**Affected Publication:** API Specification 17D, *Specification for Subsea Wellhead and Tree Equipment*, 3<sup>rd</sup> Edition, October 2021

## Addendum 1

**Table 8 —API-type SBX Pressure-energized Ring Gaskets**

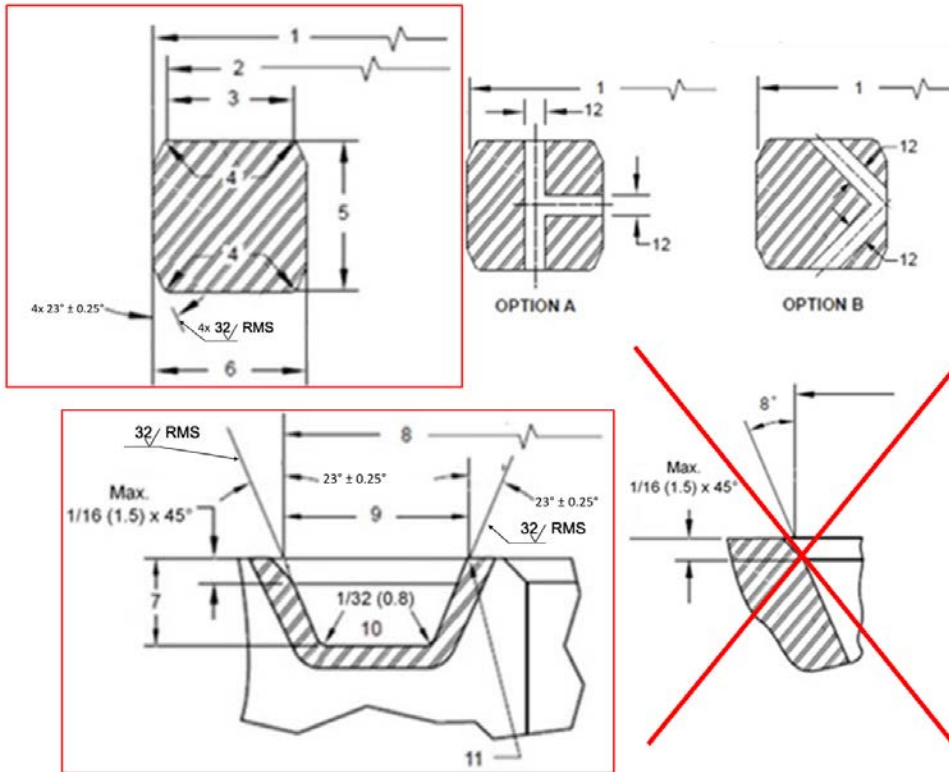
**Table 8: Table shall be changed to the following:**

NOTE 1 Radius  $R$  shall be 8 % to 12 % of the gasket height,  $H$ .

NOTE 2 Two pressure passage holes in the SBX ring cross section prevent pressure lock when connections are made up underwater. Two options are provided for drilling the pressure passage holes.
